Memorandum to the City of Markham Committee of Adjustment

August 24, 2020

File: A/070/20
Address: 95 Emmeloord Cres Markham
Applicant: Jim Kalogiros
Agent: Gregory Design Group (Russ Gregory)
Hearing Date: Wednesday, September 02, 2020

DRAWINGS REVISED - AUG 09/20

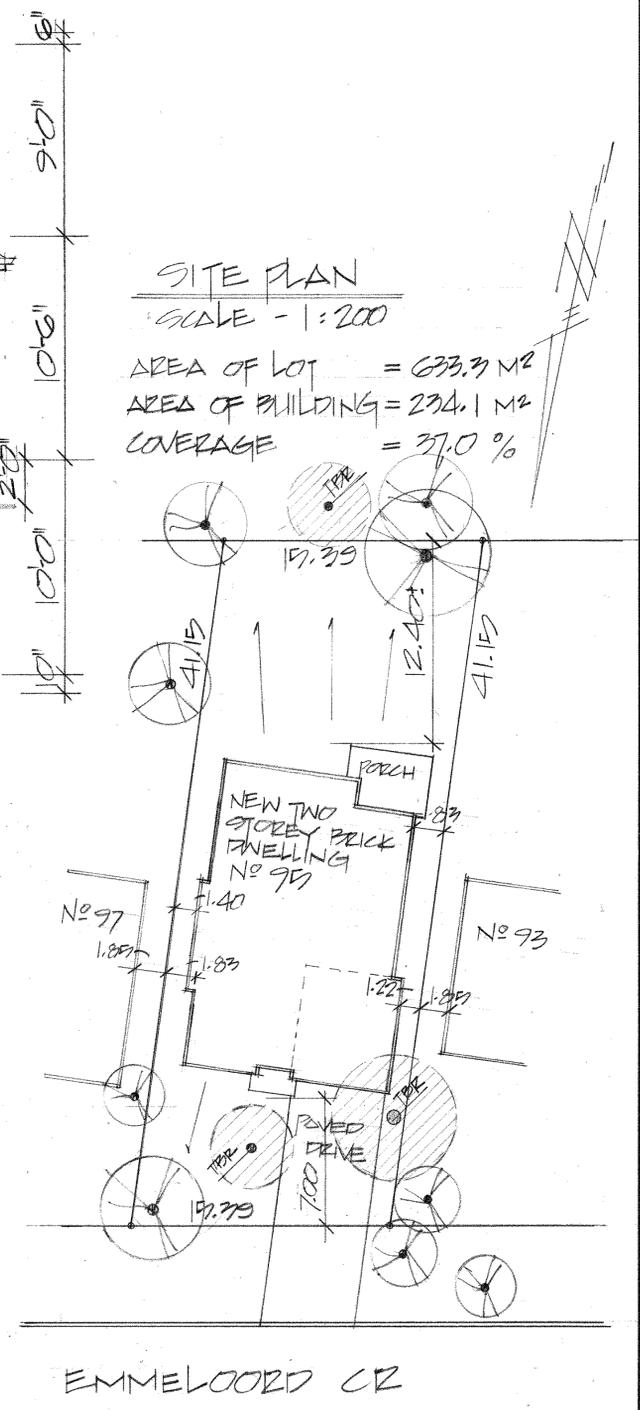
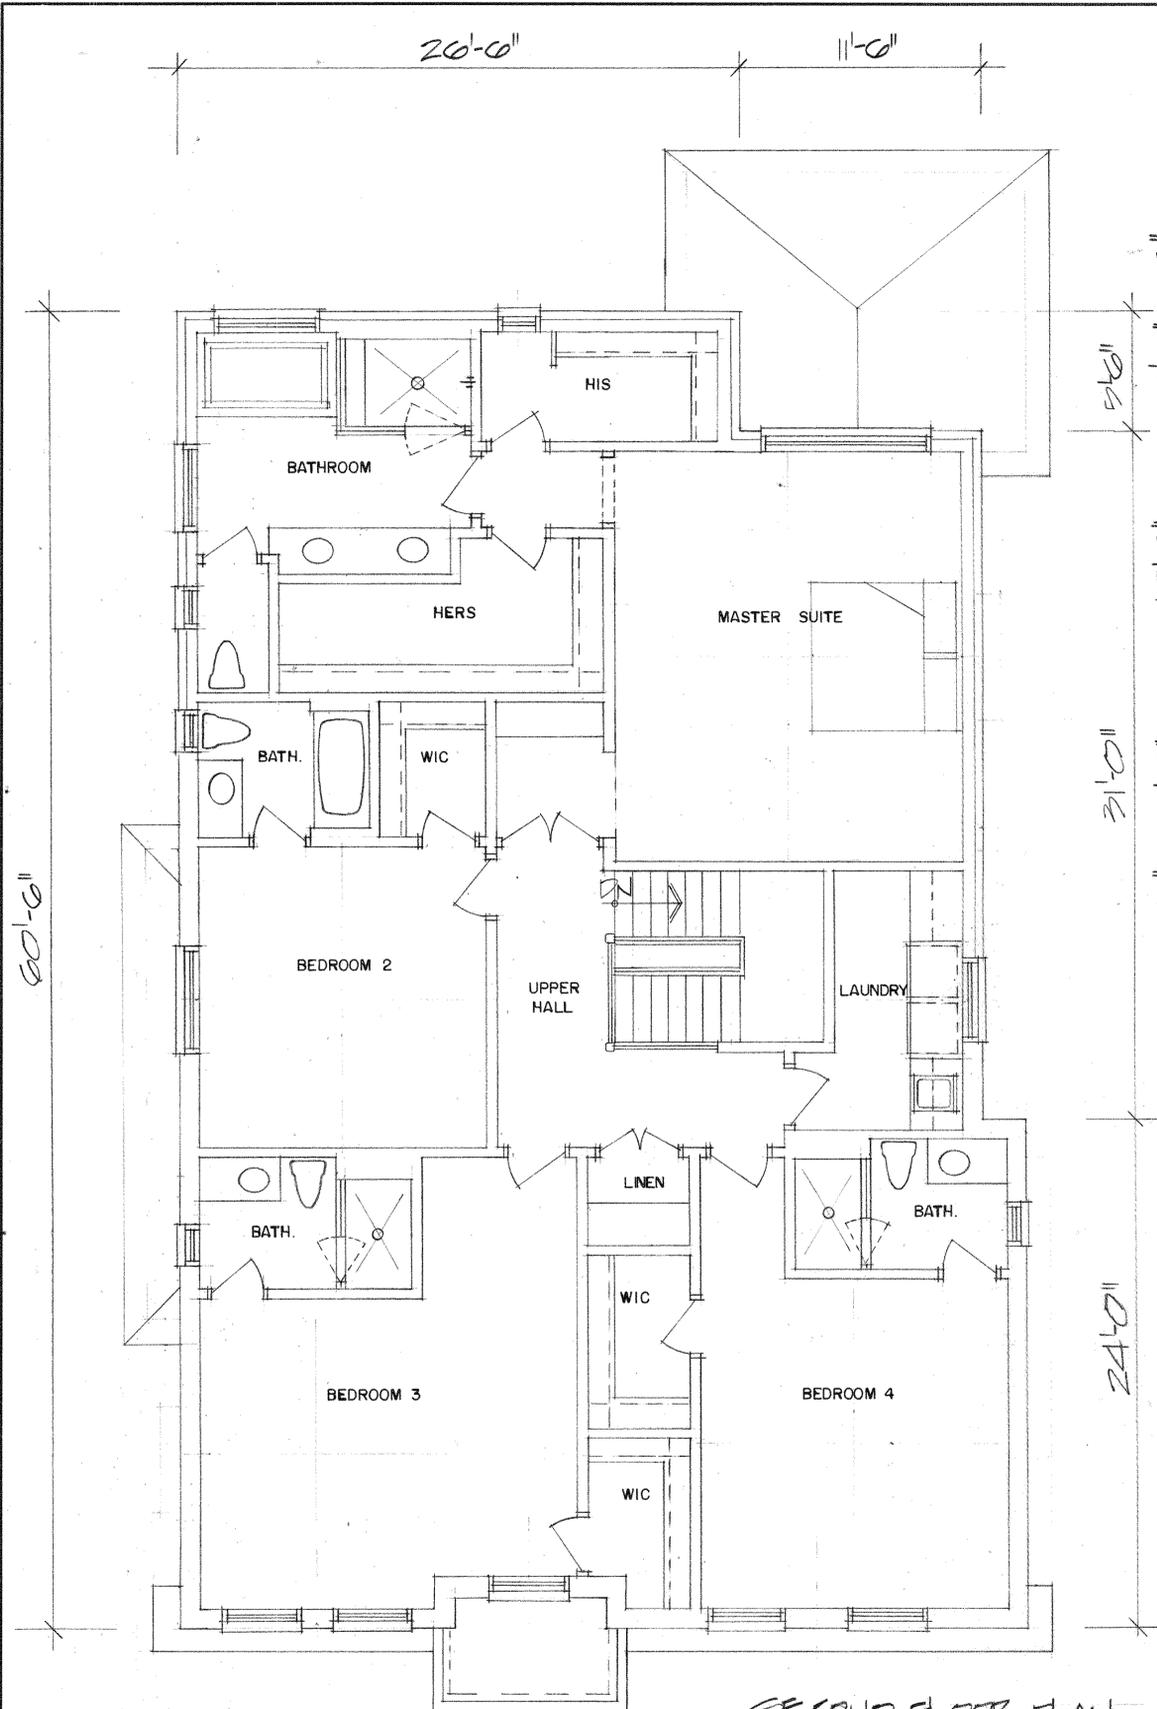
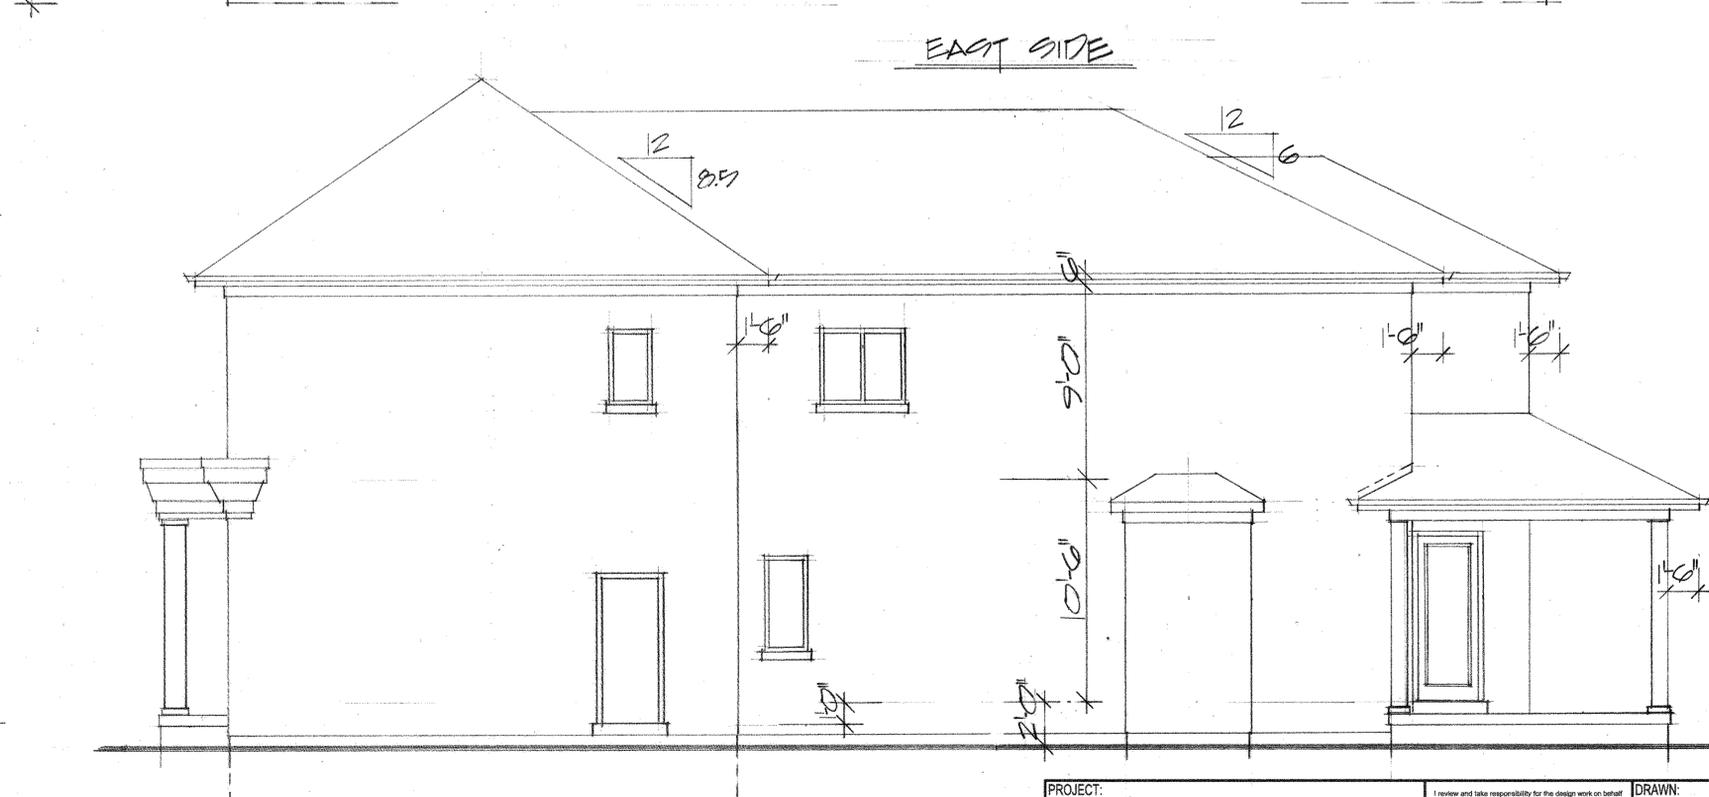
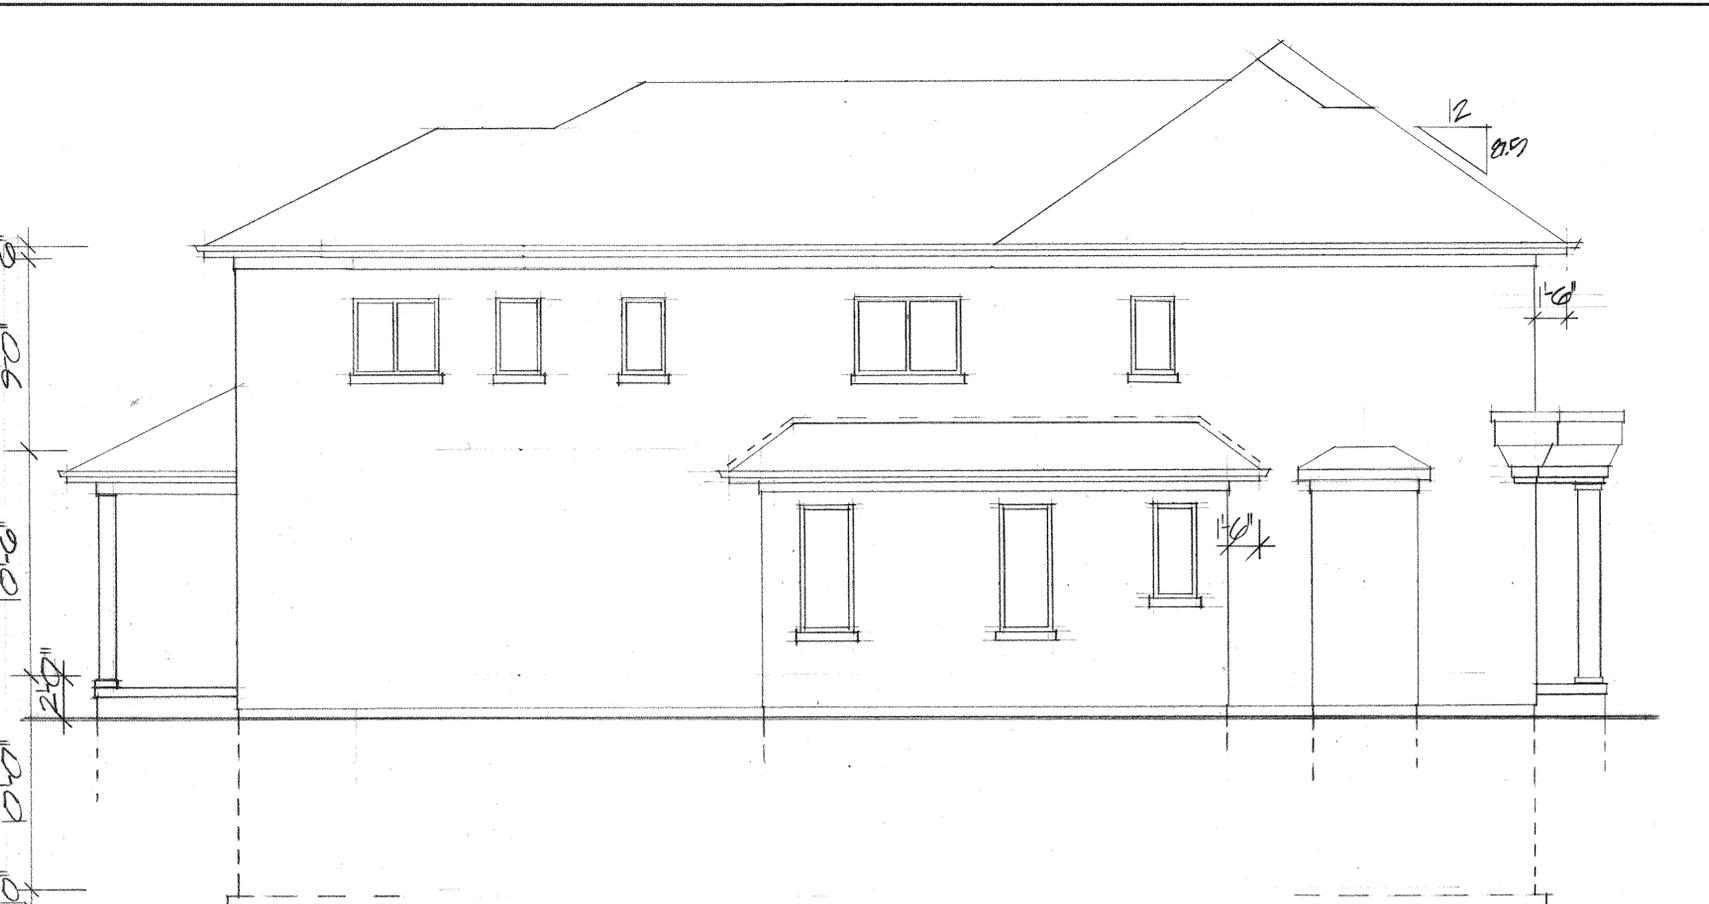
This application was deferred at the July 29, 2020 Committee of Adjustment hearing as detailed in the minutes extract (Appendix "D"). The applicant submitted revised plans for the proposed development on August 7, 2020 (Appendix "B"), which maintain three of the previously requested variances as they relate to building height, front yard setback, and reduced side yard setbacks along the western and eastern property lines. The revised plans show a reduction in the area of the front porch and first floor mud and coat rooms, resulting in a reduction to the proposed lot coverage from 40.3 percent to 37 percent. Further, the revised proposal no longer includes a cabana structure in the rear yard, resulting in the exclusion of a previous variance request for a reduction to the rear yard setback for an accessory building.

Staff have reviewed the revised plans and advise that the comments from the initial staff report remain applicable (Appendix "C"). Staff are of the opinion that the requested variances would result in a development that is compatible with the surrounding area context and, appropriately reflects the recent infill development

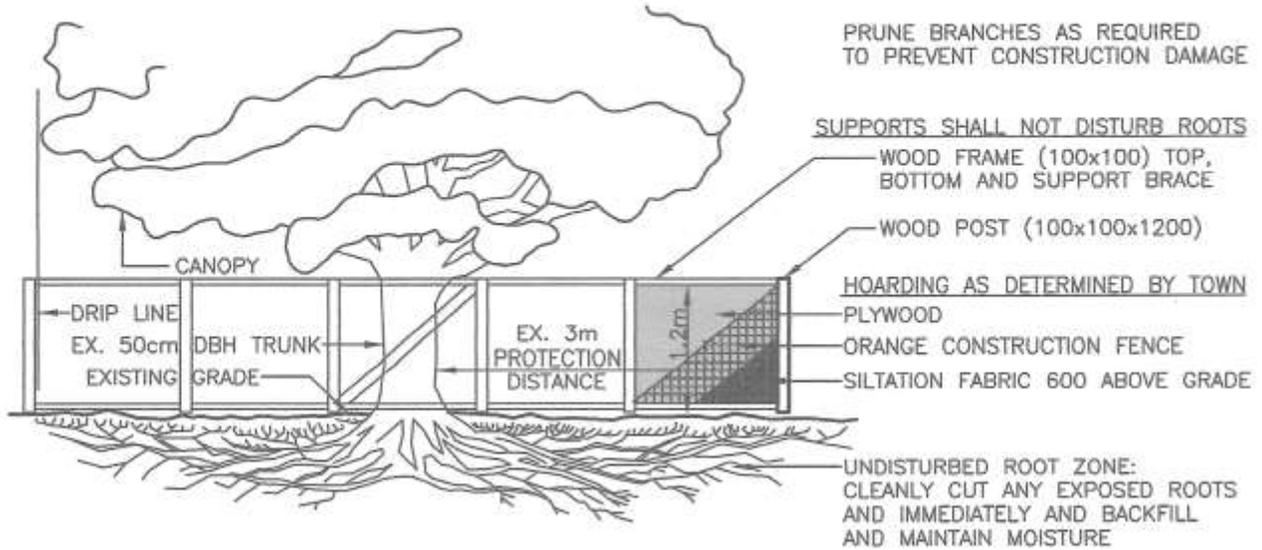
Arb Monitor - Undertaking horizontal

Neighbour-Monitor

Hand dig, arb monitor, undertaking

Hand dig, arb monitor, undertaking

Consent - Neighbour
